# Access Compliance Report

## Public Rights-of-Way

### (Curb Ramps)

Intersection ID: 42769	Main Street: ERWIN_RIDGE_AV	Cross Street: JEANETTE_CR	Location: SE
ADA ID: A691320D484C	Ramp Type: PerpDiag	Initial Pass/Fail: Fail	Overall Compliance: No
		Severity Score: 30

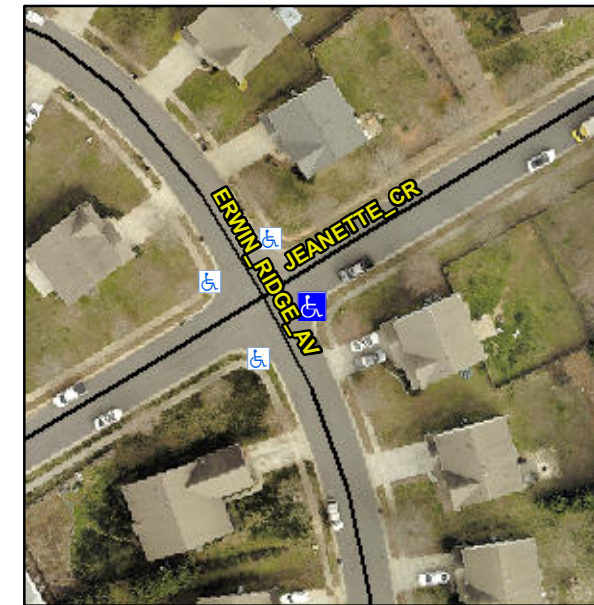
**Not Found, R304.5.1, R304.5.3**

Compliance	Description	Data	Compliance	Description	Data
N/A	Ramp Length (in)	52.0	Yes	Ramp Slope (%)	6.7
No	Ramp Width (in)	34.0	No	Ramp XSlope (%)	6.8
N/A	Flare Type LT	N/A	N/A	Flare Type RT	N/A
N/A	Flare Slope LT (%)	N/A	N/A	Flare Slope RT (%)	N/A
N/A	Flare Traversable LT?	N/A	N/A	Flare Traversable RT?	N/A
N/A	Landing Length (in)	N/A	N/A	DWS Provided?	N/A
N/A	Landing Width (in)	N/A	N/A	DWS Contrast?	N/A
N/A	Landing Slope (%)	N/A	N/A	DWS Length (in)	N/A
N/A	Landing X Slope (%)	N/A	N/A	DWS Full Width?	N/A
N/A	Landing Curb? (Y/N)	N/A	N/A	DWS Offset (in)	N/A
N/A	Shared Landing?	N/A			
N/A	Gutter Ponding?	N/A	N/A	Gutter Slope (%)	N/A
N/A	Gutter Lip Ht (in)	N/A	N/A	Gutter X Slope (%)	N/A
N/A	Painted X Walk1?	No	N/A	Painted X Walk2?	No
	X Walk 1 Direction	To N		X Walk 2 Direction	To W
N/A	X Walk 1 Width (in)	N/A	N/A	X Walk 2 Width (in)	N/A
	X Walk 1 Slope (%)	4.7		X Walk 2 Slope (%)	0.8
	X Walk 1 X Slope (%)	2.9		X Walk 2 X Slope (%)	7.9

**Remove & Replace Curb Ramp With Two New Directional Ramps or Equivalent.**
